MONTGOMERY COUNTY HISTORIC PRESERVATION COMMISSION
STAFF REPORT

Address:	5904 Cedar Parkway, Chevy Chase	Meeting Date:	10/28/2020
Resource:	Outstanding Resource Chevy Chase Village Historic District	Report Date:	10/14/2020
Applicant:	David O'Neil & Laura Billings (David Jones, Architect)	Public Notice:	10/7/2020
Review:	HAWP	Tax Credit:	Partial
Case Number:	35/13-18Z (REVISION)	Staff:	Dan Bruechert
Proposal:	Front Terrace Alteration

Re: HAWP Case No. 35/13-18Z

Figure 2: 1927 sales advertisement for the subject property.

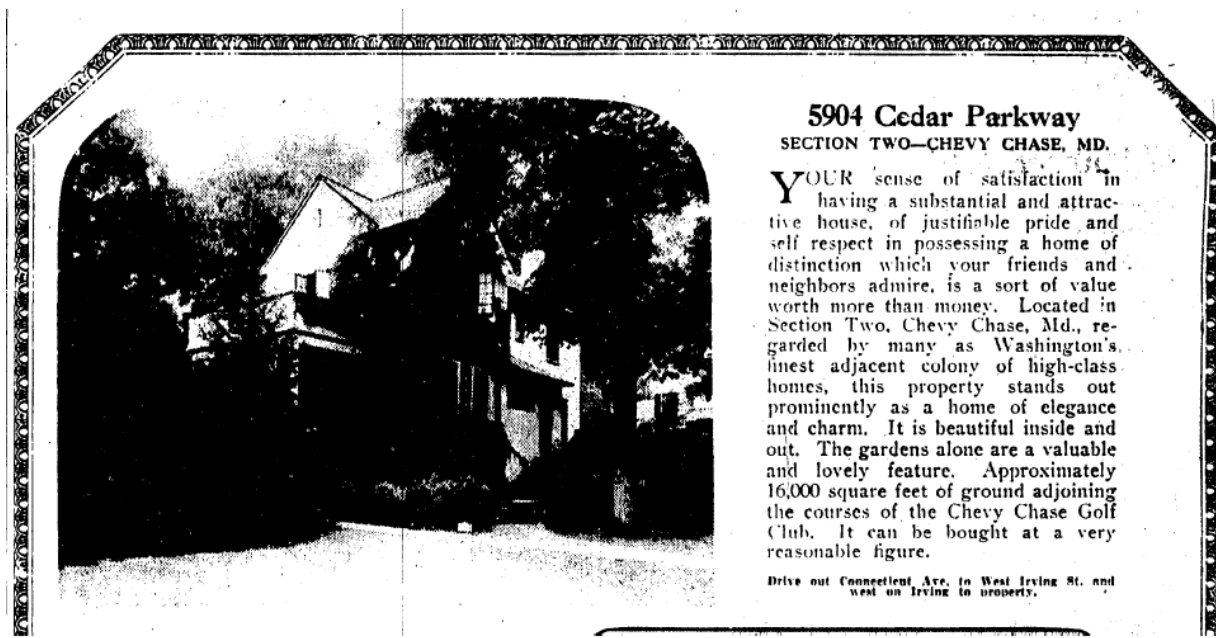
The applicant proposes three justifications for reconfiguring the front terrace stairs. The first justification is that the information in the District Master Plan Amendment is incorrect. The house is designated as an 'Outstanding' resource to the district and the notes identify that the house was designed by "A. Morrill" and was constructed out of reinforced concrete. Staff has been unable to determine if the house was designed by Milton Dana Morrill or his studio. However, Staff examined the house while rehabilitation work was ongoing and can state unequivocally that it was built using traditional frame construction with a stucco exterior. The file for the Chevy Chase Village Historic District does not provide any additional information to justify the 'Outstanding' designation for the subject property. Staff finds that the information the HPC and County Council relied on to make their determination for the subject property was erroneous.

Staff reviewed all of the other properties along Cedar Parkway, and while many of the neighboring buildings are substantial, they are all designated as 'Contributing' to the district. While it would take a formal act of the County Council to change the level of designation, Staff finds that the HPC can consider the proposal in light of the documentation presented.

Figure 6: Detail image showing proposed fencing and change in grade.

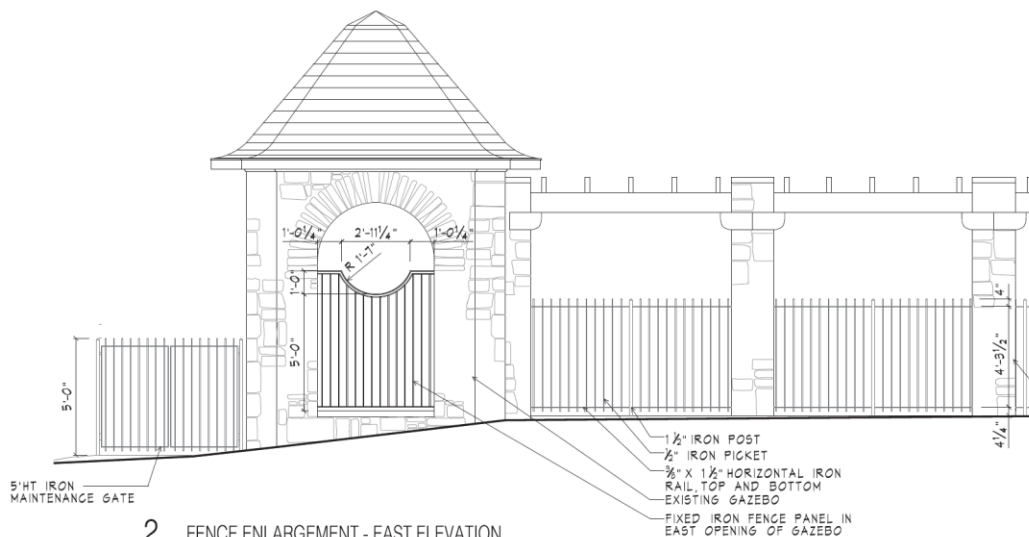
The gate proposed to the left of the gazebo matches the details of the proposed fencing throughout the project. The fence height, 5’ (five feet), exceeds typical HPC guidance; however, Staff supports its approval for a number of reasons. First, the lot slopes down to the south, as seen in the figure below. The top of the gate is several feet below the fencing in the pergola. Second, because this portion of the fence is so far away from the house, it will have less of a visual impact than fencing that is closer to the house. Staff finds that this gate is not a substantial

alteration to the historic house (Chapter 24A-8(b)(1) and will not detract from the historic character of the site (per Standard 2). Staff supports approval of the proposed fencing.
